OVERLOOK AT SPICEWOOD SPRINGS

4920 SPICEWOOD SPRINGS RD
SPC-2015-0317C

Overlook at Spicewood Springs, Case No. SPC-2015-0317C

Critical Environmental Features near proposed building

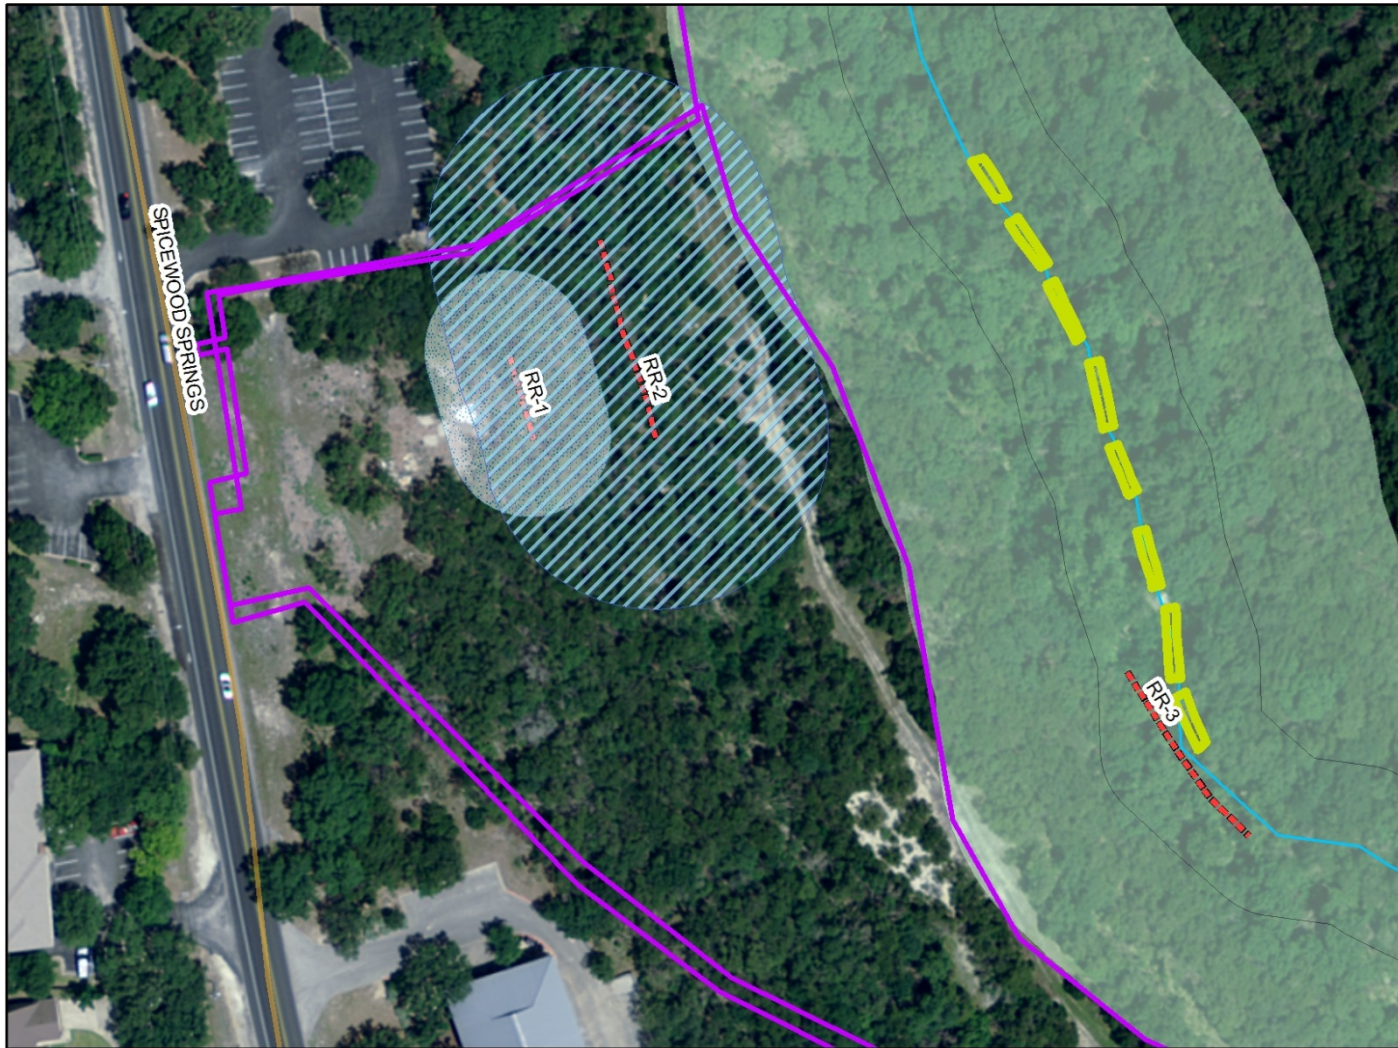
A variance is requested to reduce the Critical Environmental Feature (CEF) buffers of 2 canyon rimrocks (RR-1 and RR-2) from the standard 150-foot distance. The proposed buffer width for RR-1 is 50 feet and for RR-2 is 106 feet.

Due to the criteria of ECM 1.10.4.A.1 (slopes > 15% upslope of RR-2), the variance to reduce the buffer of RR-2 could not be approved administratively. Although site characteristics of RR-1 do meet the criteria of ECM 1.10.4.A. for a possible administrative variance, the applicant chose to request CEF buffer reduction for RR-1 from the Zoning and Platting Commission.

Canyon Rimrock Critical Environmental Features on Overlook at Spicewood Springs, SPC-2015-0317C

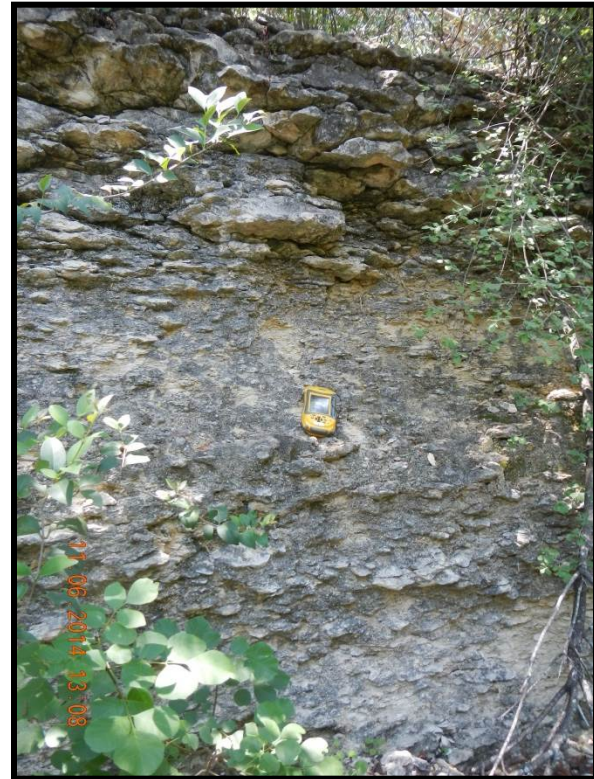
Variance request to
reduce the CEF buffer to
50-foot radius for RR-1,
located at the top of the
canyon rim

Variance request to
reduce the CEF buffer to
106-foot radius for RR-2,
located downslope of
RR-1

The applicant will provide Jersey barriers in addition to silt fence along the downslope portion of the Limit of Construction. This will offer structural reinforcement to silt fence; silt fence will reduce transport of sediment beyond the Limit of Construction. Also, mulch logs will be placed downslope of the Jersey barrier in the area upslope of canyon rimrock RR-1 as an additional measure to capture sediment.
